RCS Comments

8 October 2018

Policy H4 : Rock Channel, Site A is allocated for a mixed use development of 30 dwellings in this location, subject to the following criteria:

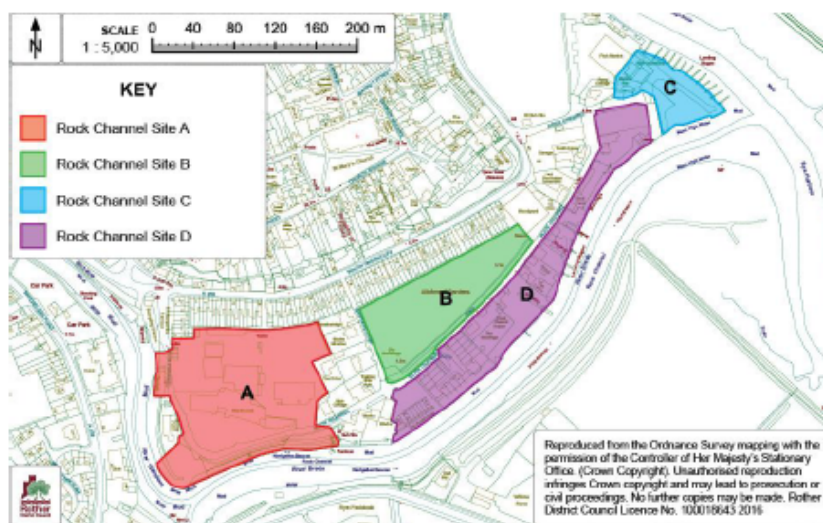
The Society welcomes the broader approach to the development of this site but remain concerned as to the requirement that any development 'will need to be undertaken on a comprehensive basis and/or according to a masterplan'. The reality is that the site is in 2 separate ownerships and there is no guarantee that they will be developed at the same time. Who therefore, is to develop a masterplan? The best that can be achieved is surely for the developer of one site to ensure that access to the other is provided for and then to rely on the design principles contained in the Core Strategy and the RNP to be applied to both sites. What is the problem if the two sites are developed in a different style as it is the very mixture of styles and materials that make Rye so attractive.

We believe that the policy should be expanded to require that the design 'creates a strong sense of place' within the two likely development sections.

Fig 17

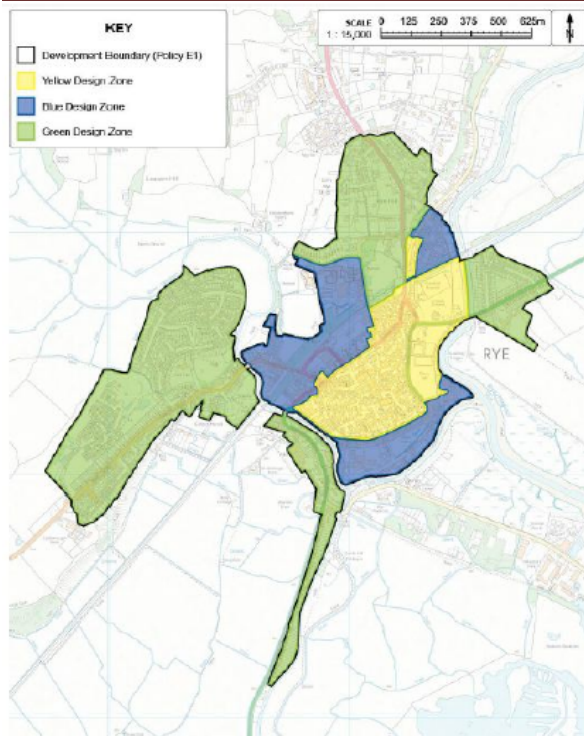
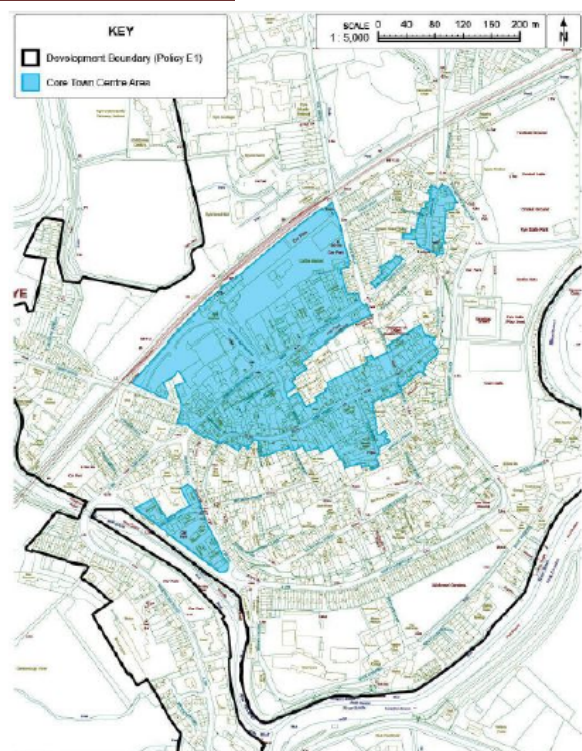
Fig 12 in clause (b) should be omitted as there are differing blue zones on both plans or the clause reworded.

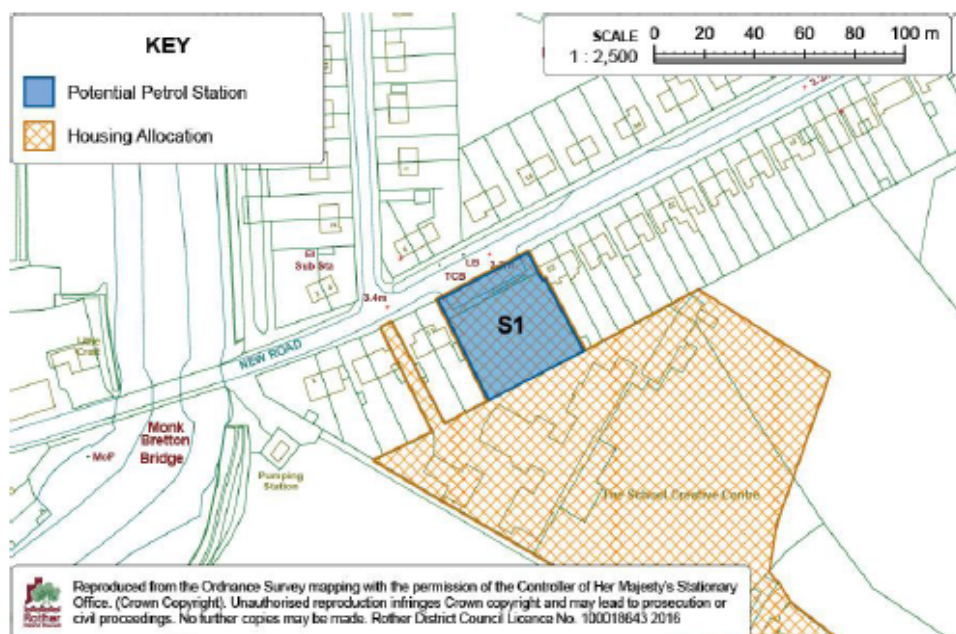
Should not clause (a) refer to zones yellow and blue rather than green as the majority of what is in zone green is post war residential which hardly counts as an area with 'reasons to visit'.

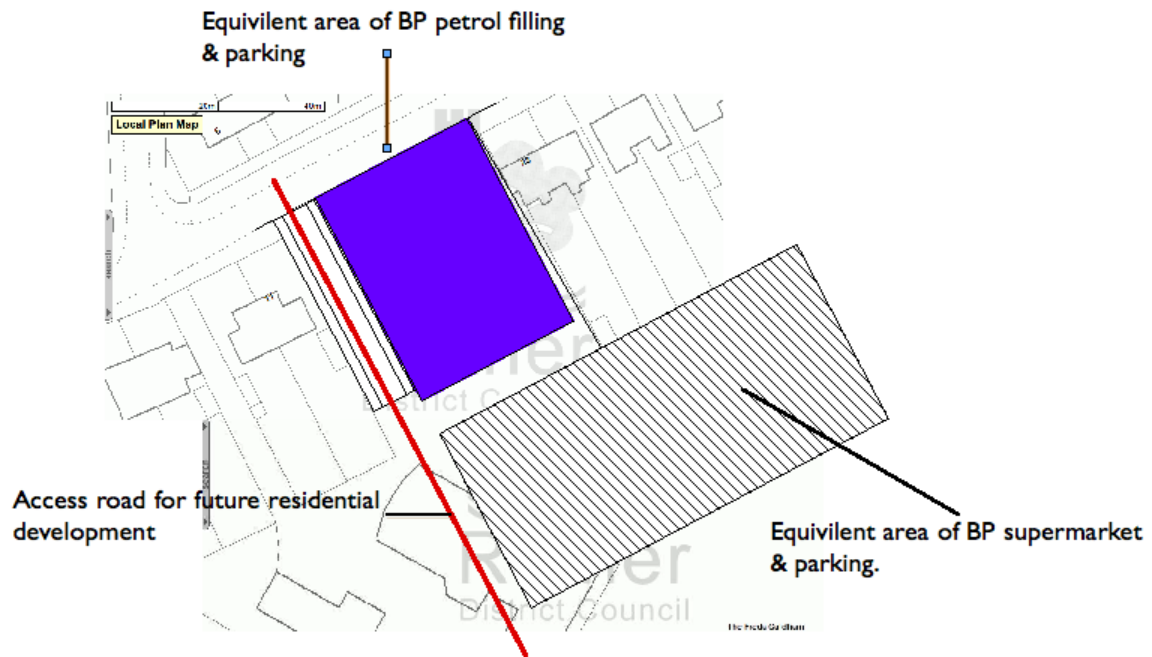
Whilst the Society agrees that this location for a petrol filling station is more appropriate given its location on the A259 and its proximity to the centre of Rye, it is unlikely that such a development is unlikely to be undertaken without an accompanying small supermarket to make the development finances work. Our concern is that the site S1 is not large enough as shown for both. If it is compared to the application by BP (allowing for a suitable access road of 5m with pavement) then the extent of the site required indicates the undersizing of S1 and the extent to which H7 would be eaten into. See plan below.

Limiting the site area for a potential filling station would allow a potential developer to argue that the site is impractical on cost viability grounds and therefore increase pressure on sub optimal sites elsewhere.

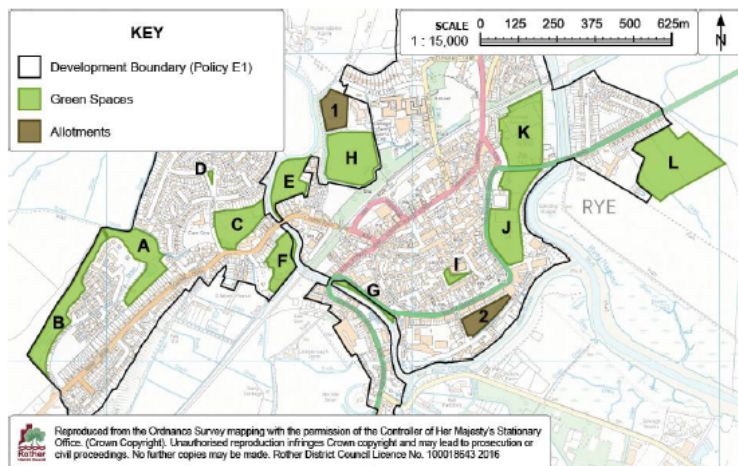
The Society is unclear as to whether these ‘green spaces’ are Local Green Spaces as defined by NPPF para 77 as if they are meant to be some do not meet the NPPF criteria. If LGS are to be designated then these should be C, H, J, K & L.

We find it odd that the most protected open area in Rye, St Mary’s Churchyard which is part of the curtilage of a Grade I listed building, is consecrated ground and in the Conservation Area, is included within this list.
